**PRODUCT INFORMATION BULLETIN**

SUBJECT: Control Panel Sealing Improvement

MODEL AFFECTED: 04270-0, 1, 2 **Serial number range — From 3222192 to 3579950 only**  
Installed in Alfa Leisure coaches

### **PRODUCT INFORMATION BULLETIN**

**FIGURE 1**

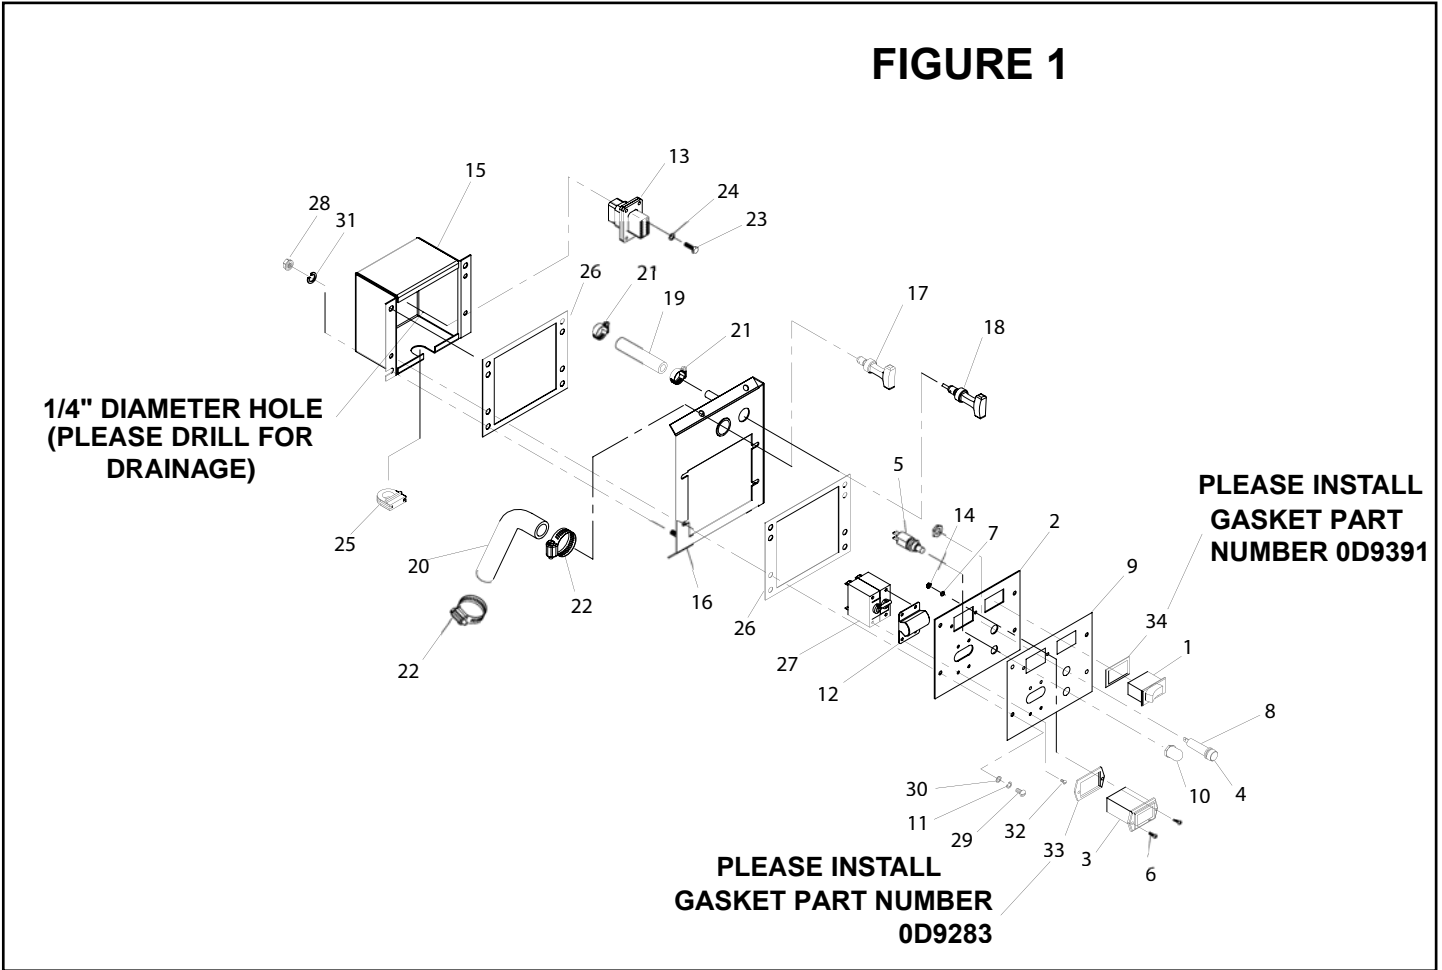
PROBLEM: Possibility of water intrusion into the control panel

CORRECTIVE ACTION: Install hour meter gasket and Start/Stop switch gasket. Drill drainage hole in panel box.

3. Remove the four panel screws and pull the panel face assembly out and away.
- 4. In the bottom right hand corner of the panel box, drill a 1/4" diameter hole for drainage. See Figure 1.**

5. Remove hour meter screws and remove hour meter from panel face.
- 6. Remove two wires from hour meter and slide gasket 0D9283 into place. See Figure 1.**

- 9. Slide gasket 0D9391 over the switch body and flush with the switches trim bezel. See Figure 1.**
10. Return the wires as removed. When looking at the rear of the Start/Stop switch with the three terminals located toward the top, wire number (17) seventeen (start) is on the left terminal, wire number (0) zero (ground) is on the middle terminal and wire number (18) eighteen (stop) is on the right terminal.

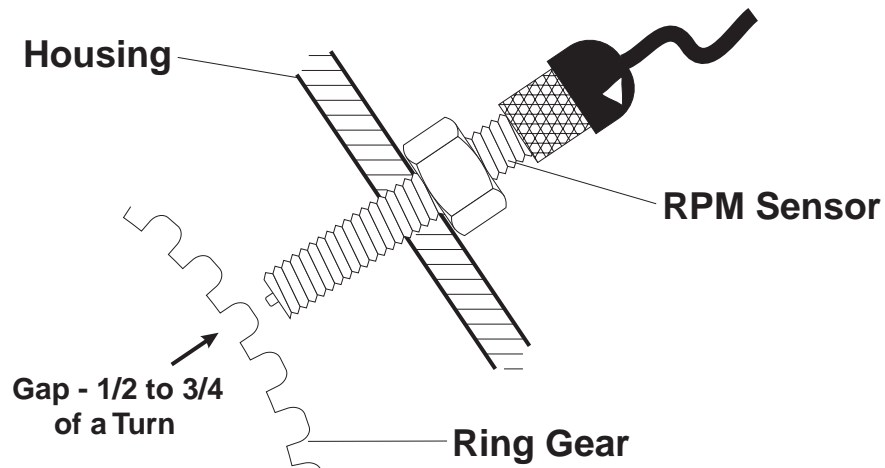
If the magnetic pickup is removed for any reason, it must be installed properly. Rotate the ring gear until a gear tooth face is directly in the center of the tapped hole. Gently turn the magnetic pickup clockwise into the tapped hole until it bottoms on the gear tooth, then back it off **1/2 to 3/4 of a turn** and tighten the jam nut securely.

**Drawing No. 0C2091-D**

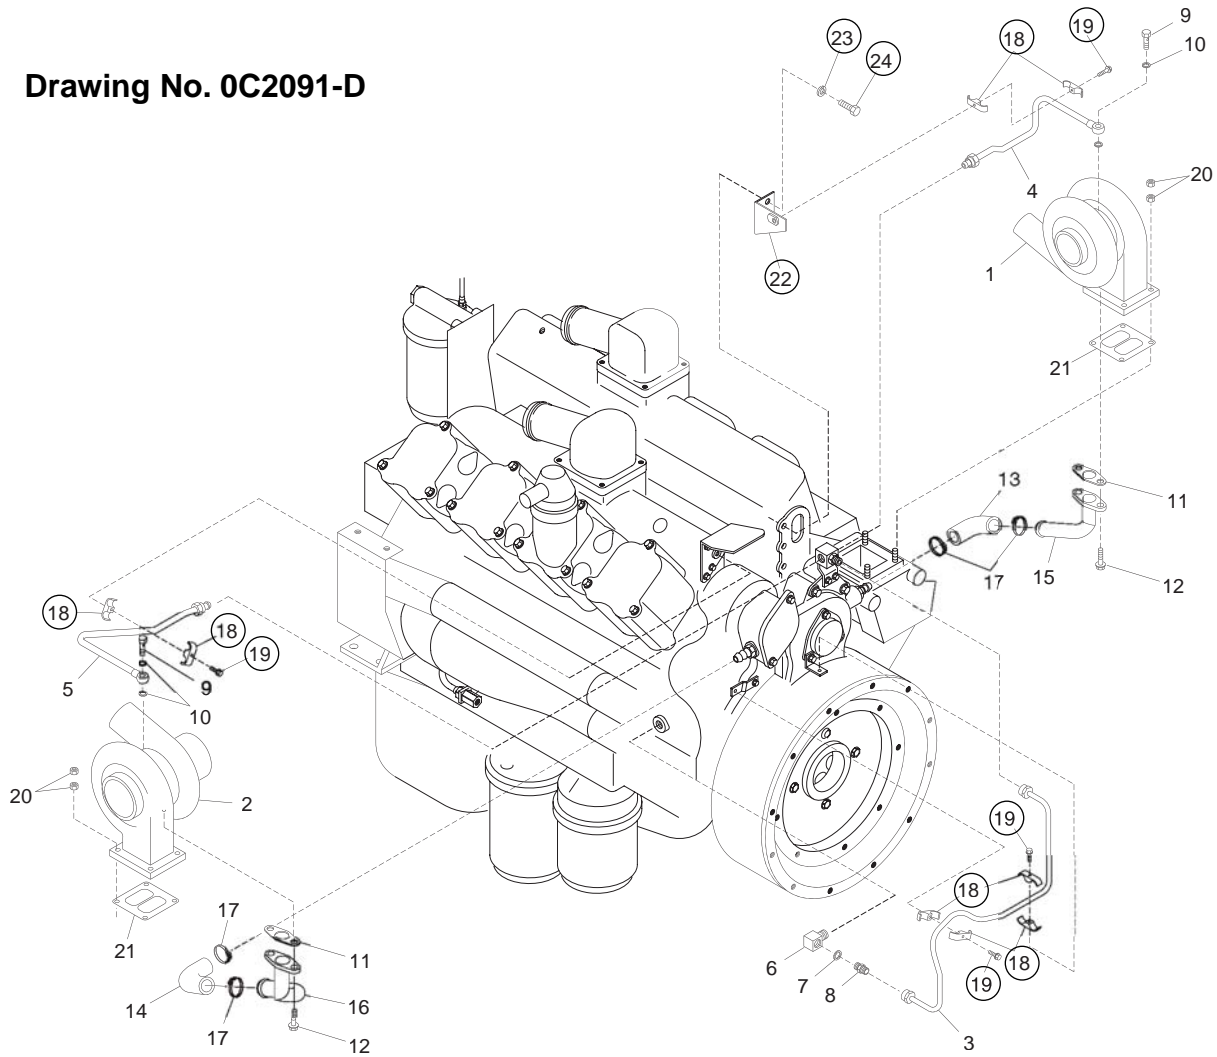
PROBLEM: Possible oil feed tube leakage (turbos).

CORRECTIVE ACTION: Inspect all tubes and fittings for leaks or damage (repair or replace as needed). Install Kit Number 0E1231 per drawing on page 2. This will secure the oil feed tube lines.

Figure 2

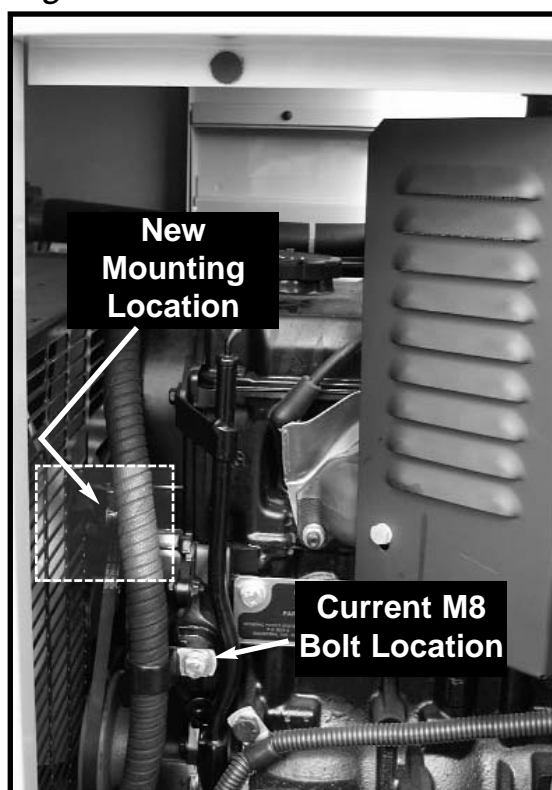
**PROBLEM:** Chaffing of fuel hose on the engine timing belt cover

**CORRECTIVE ACTION:** Move fuel hose hold down clamp and fuel hose to new position.

1. Remove M8 bolt from clamp located on the side of engine block. See Fig. 1
2. Reposition fuel hose and clamp to new mounting location on timing belt case cover. See Fig. 2
3. Replace M8 bolt and tighten. See Fig. 2
